XJ303-S717

TECHNICAL BULLETIN

Oil Cooler Pipe Interference With Cross Brace – Service Action S717

MODEL 2004 MY
XJ range

ILLUSTRATION 1

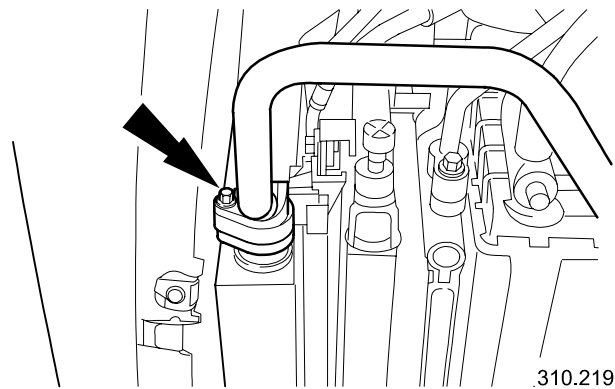
A concern has been identified with the oil cooler return pipe on 2004 XJR vehicles within the above VIN range. The original design of the oil cooler pipe does not give adequate clearance to the cross brace. This can allow the oil cooler return pipe to interfere with the cross brace and, in some cases, contact the front securing bolt of the air deflector. This can cause the oil cooler return pipe to leak, resulting in engine oil on the underside of the vehicle and possible damage to the engine.

At the next service opportunity, change the oil cooler return pipe and replace the air reflector front retaining bolts with revised shorter bolts.

5. Remove the bolt securing the oil cooler return pipe to the cooler (Illustration 1).
6. Place a suitable oil drain tray under the vehicle.
7. Displace the oil cooler return pipe from the oil cooler.
8. Install suitable blanking plugs to the oil cooler and pipe.
9. Remove the bolt securing the oil cooler return pipe to the filter housing (Illustration 2).
